RE: DBR Memo
110 Grill Restaurant
256 Main Street
Memo Date 10.20.15
DRB Review Date 10.07.15

Project: 110 Grill Restaurant
Project Location: 256 Main Street, Frontage of Kmart Lot, Acton, MA
Memorandum Date: 10.20.15

110 GRILL

FLOOR PLAN SKETCH

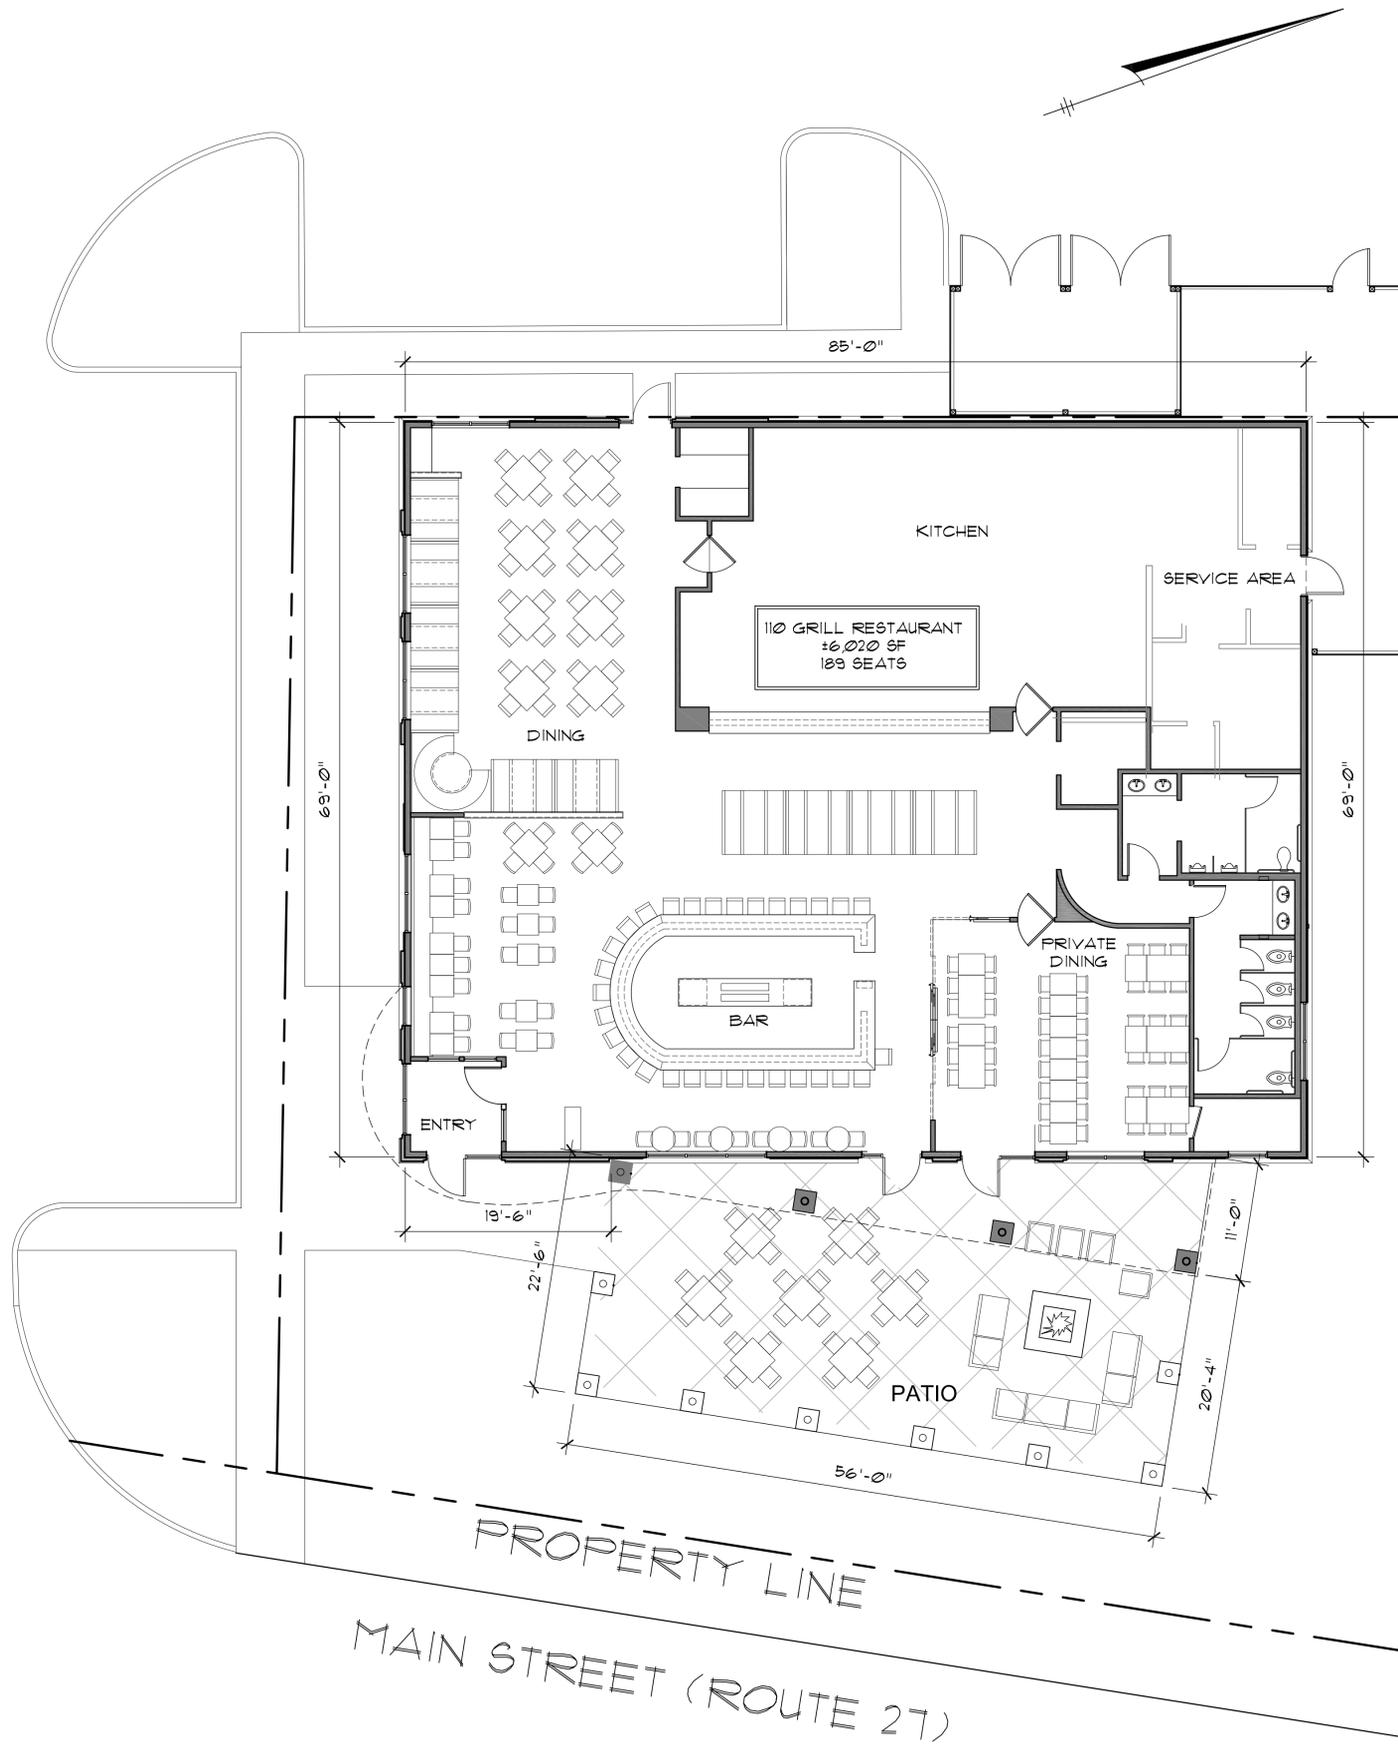
The entrance sidewalk from Main Street should be widened and coordinated with the walkway along the south elevation and the sidewalk along Main Street. A more gracious/welcoming plaza entrance area should be provided. [Has been provided.](#)

The outdoor eating patio is not integrated into the building design. It was suggested that an roof overhang/canopy of some sort be added to form a semi-outdoor eating area; i.e. there would be indoor dining; semi-outdoor dining and outdoor dining areas.

2. Along the west elevation the canopy overhang structure will extend to the property set back limit and, along with the supporting piers, will be aligned parallel with Main Street. This will both help to define the plane of Main Street and provide a partially covered patio dining area. The patio edge, parallel to Main Street, will be defined by masonry piers, set at +/-10' intervals, each mounted with a lantern and connected with decorative chain rope.
